**RE: Hanson Sancrox Quarry SSD Application No. 7293**

Accordingly, we wish to make the following submission on the proposed Hanson Sancrox Quarry expansion SSD No. 7293 documentation:

FIGURE X

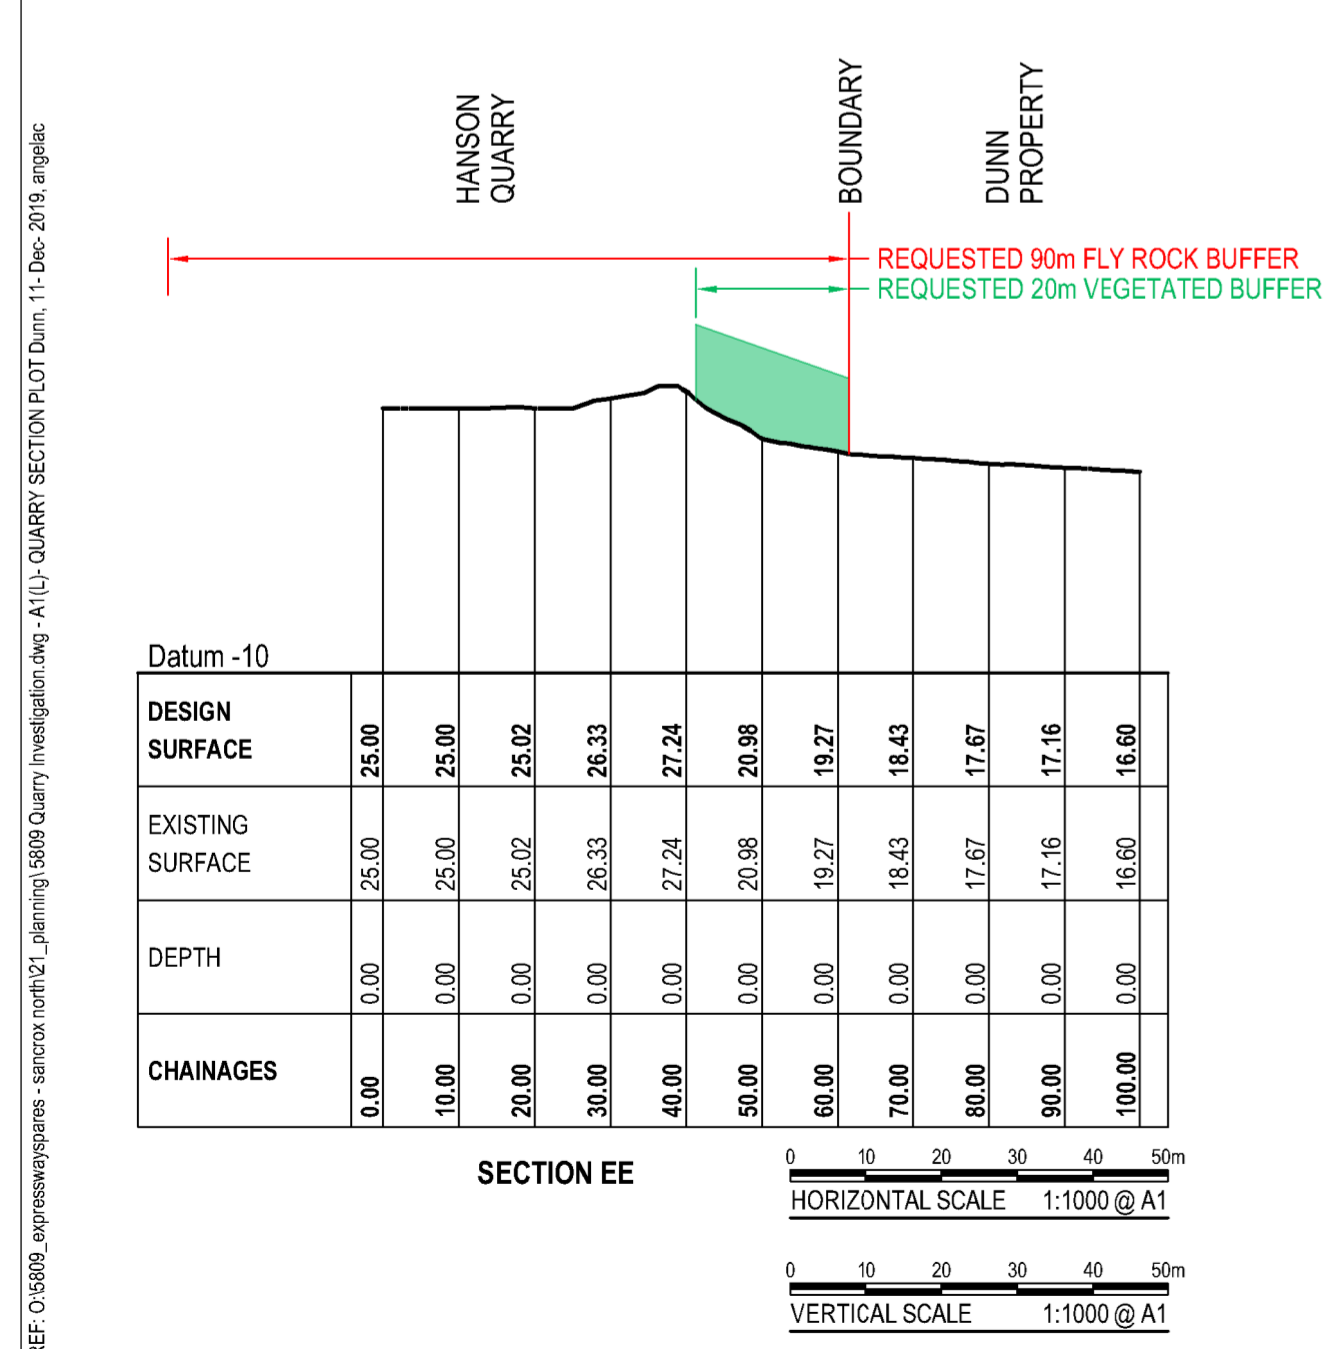
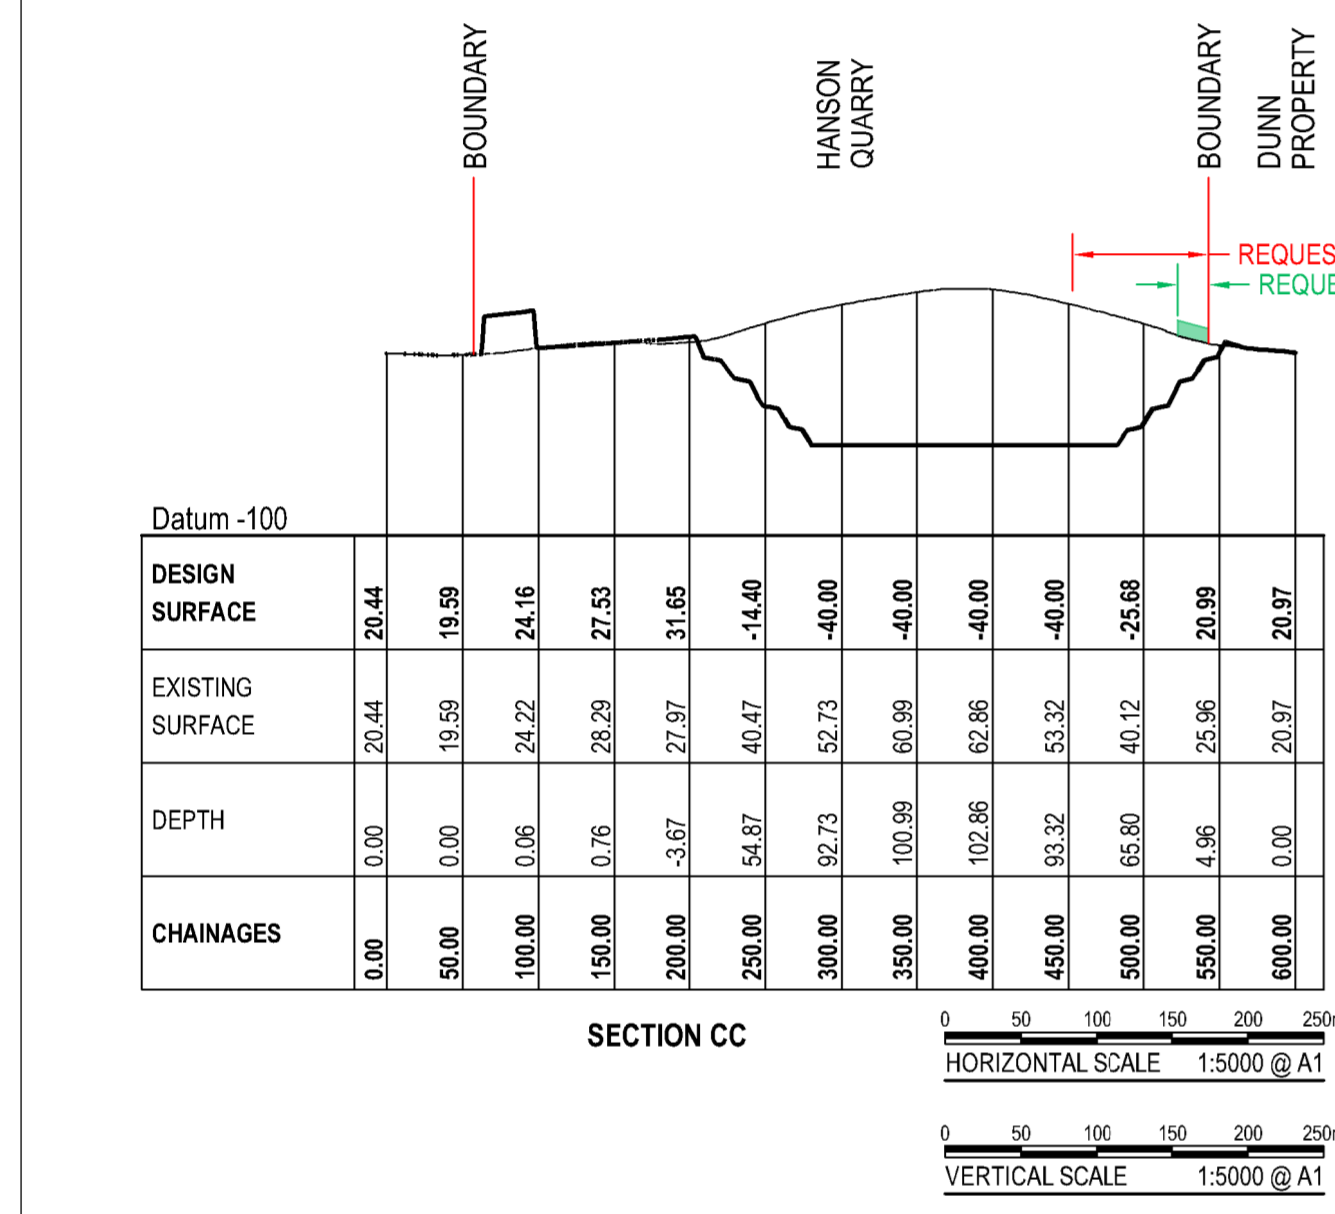
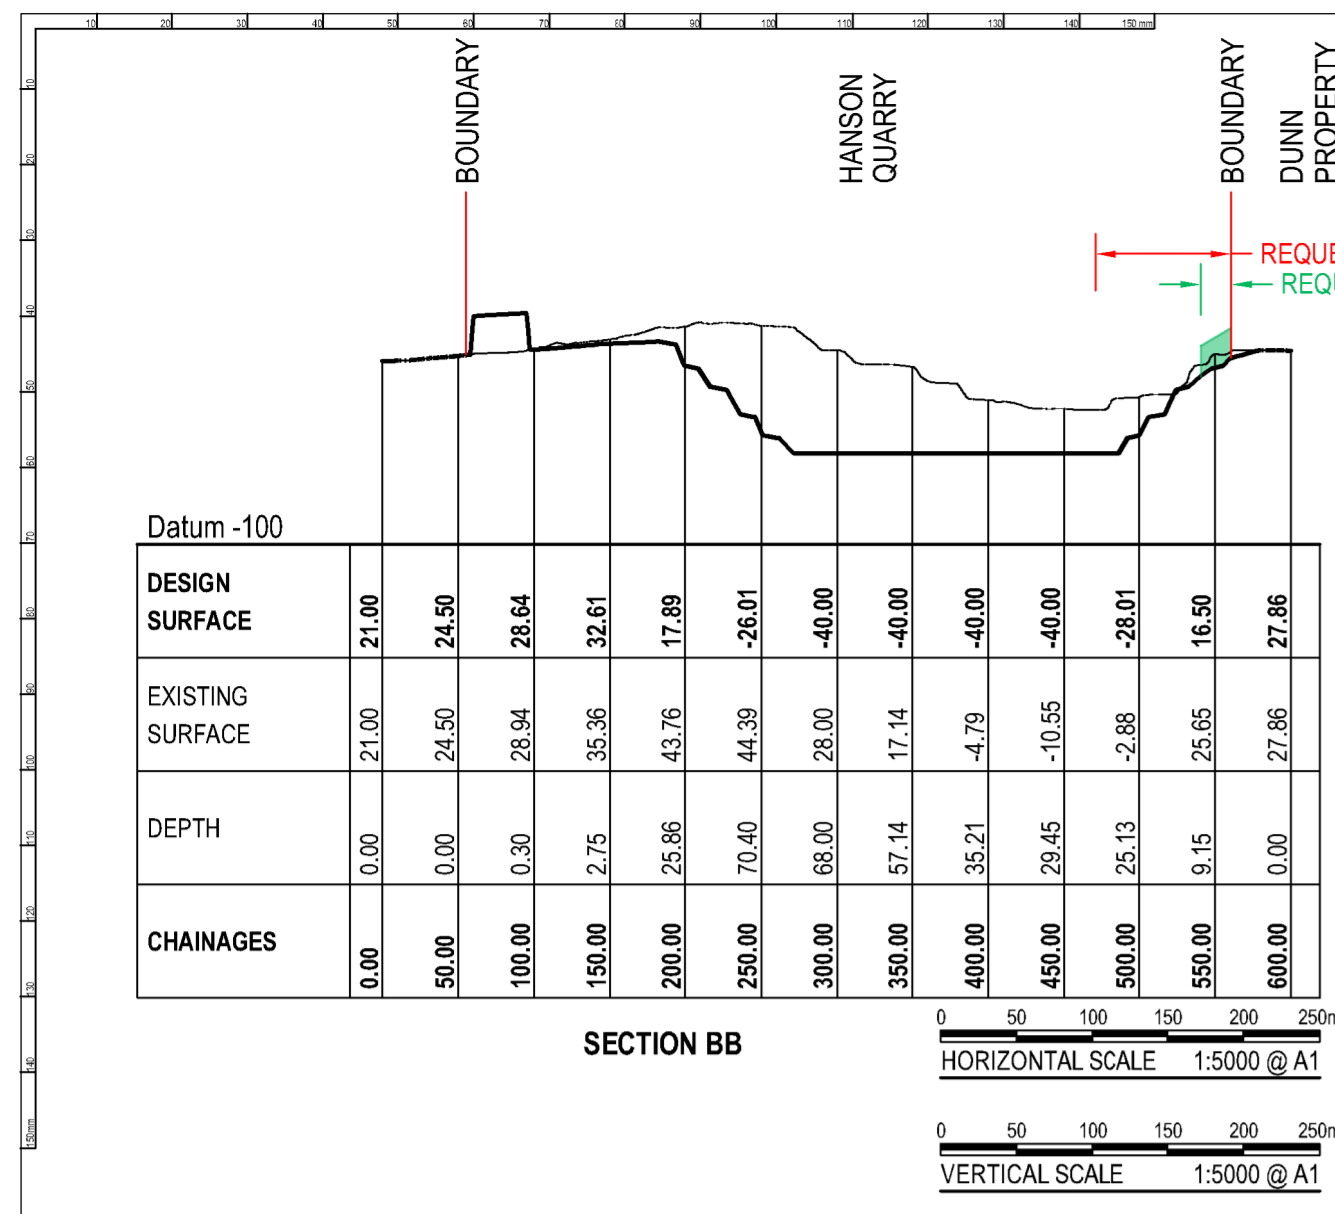
Attached at "I" is a series of plan and sections indicating the issues of flyrock buffer and screen and how we suggest they be addressed.
